PROJECT NUMBER
R2014-03527-(2)

REQUESTED ENTITLEMENTS
Vesting Tentative Tract Map No. 073203
Zone Change No. 201400013
Environmental Assessment No. 201400280

SUBDIVISION COMMITTEE REPORT

VESTING TENTATIVE TRACT MAP 073203
HARBOR CITY MIXED-USE
24906 & 24500 NORMANDIE AVENUE
& 1133 LOMITA BOULEVARD
HARBOR CITY, CA 90710
EXHIBIT MAP - GRADING/UTILITIES

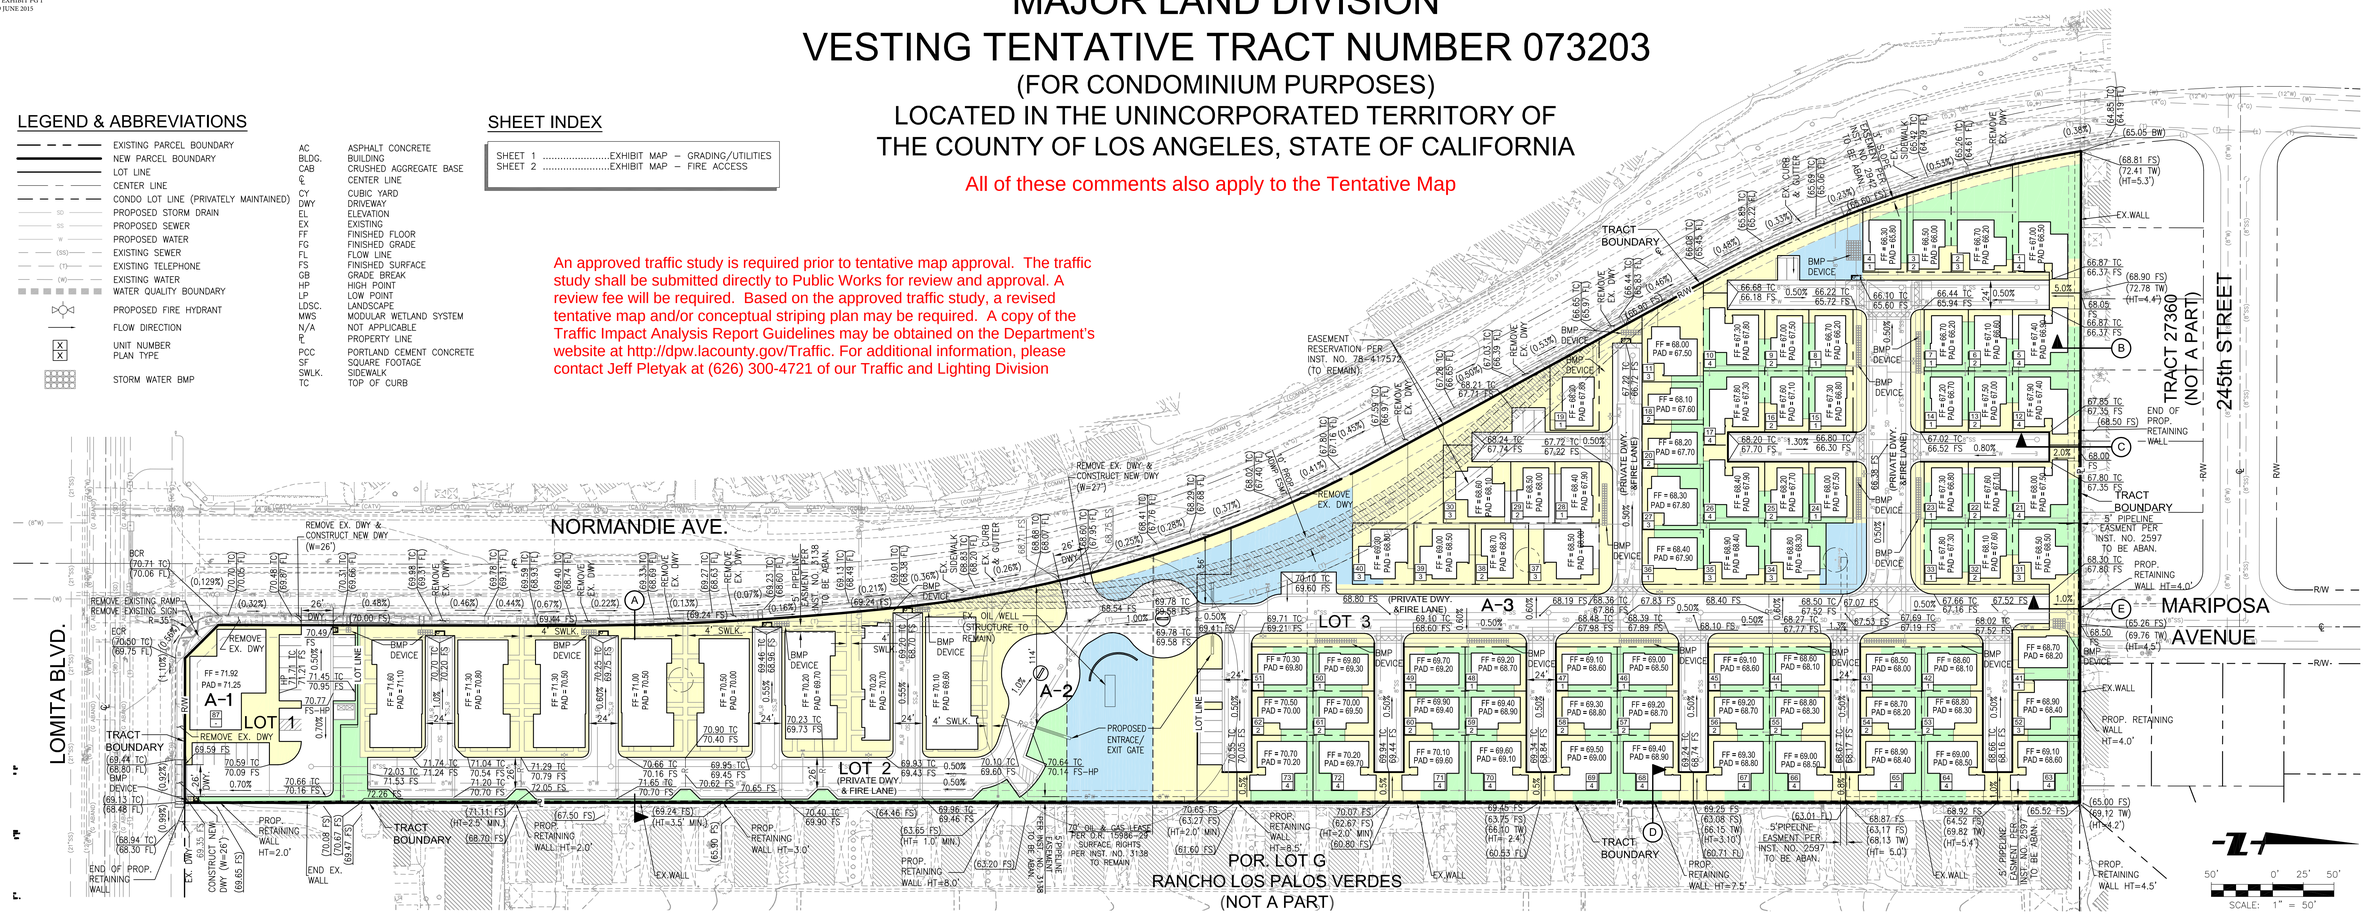
All of these comments also apply to the Tentative Map

An approved traffic study is required prior to tentative map approval. The traffic study shall be submitted directly to Public Works for review and approval. A review fee will be required. Based on the approved traffic study, a revised tentative map and/or conceptual striping plan may be required. A copy of the Traffic Impact Analysis Report Guidelines may be obtained on the Department's website at http://dpw.lacounty.gov/Traffic. For additional information, please contact Jeff Pletyak at (626) 300-4721 of our Traffic and Lighting Division

NORMANDIE AVENUE
TYPICAL SECTION NTS

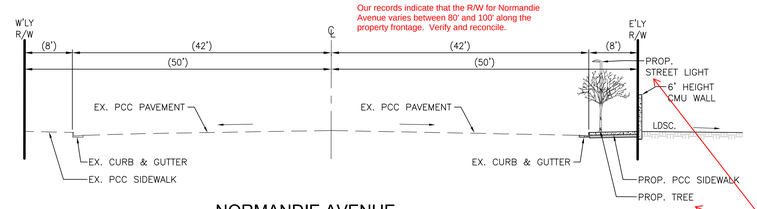
Our records indicate that the R/W for Normandie Avenue varies between 80' and 100' along the property frontage. Verify and reconcile.

LOMITA BOULEVARD
TYPICAL SECTION NTS

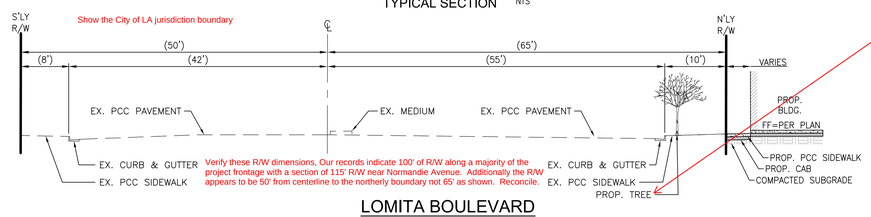
Show the City of LA jurisdiction boundary

Do not show street trees or street lights on the typical section. Remove (typ)

Verify these R/W dimensions, Our records indicate 100' of R/W along a majority of the project frontage with a section of 115' R/W near Normandie Avenue. Additionally the R/W appears to be 50' from centerline to the northerly boundary not 65' as shown. Reconcile.
